SUBJECT: POWER UPRATE WITH INCREASED CORE FLOW, SUSQUEHANNA STEAM ELECTRIC STATION, UNIT 2 (PLA-4055) (TAC NO. M88311)

The Commission has issued the enclosed Amendment No. 103 to Facility Operating License No. NPF-22 for the Susquehanna Steam Electric Station, Unit 2. This amendment is in response to your letter dated November 24, 1993, as supplemented by letters dated January 7 and February 14, 1994.

This amendment raises the authorized power level from 3293 MWt to a new limit of 3441 MWt. The amendment also approves changes to the Technical Specifications to implement uprated power operation.

**Figure 3.4.1.1.1-1
THERMAL POWER STABILITY RESTRICTIONS**

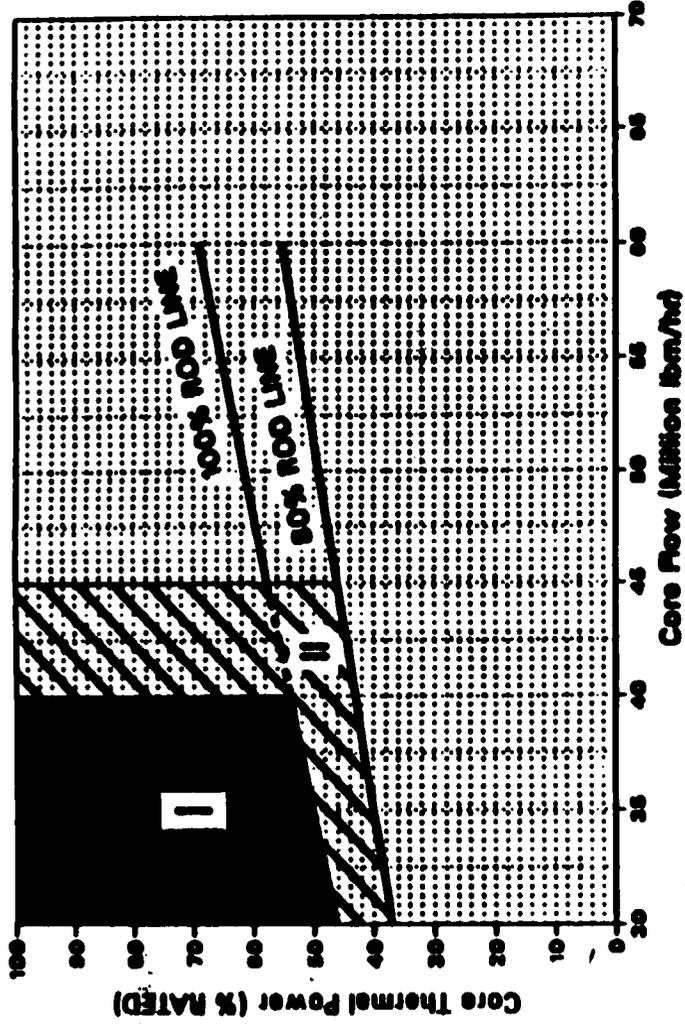
19. Figure 3.4.1.1.1-1 on Thermal Power Stability Restrictions has been redrawn to reflect the new definition of Rated Thermal Power to retain the same stability operating restrictions in terms of megawatts thermal as currently prescribed by this graph. The core thermal hydraulic stability curve and associated bases are maintained at the current rod lines and power levels. Those values are redefined to reflect the redefinition of rated thermal power. Since the current operating restrictions are maintained, power uprate has no detrimental effect on the level of protection provided by the TSs. The revised figure precludes operation in the region of potential thermal-hydraulic instability and is acceptable.
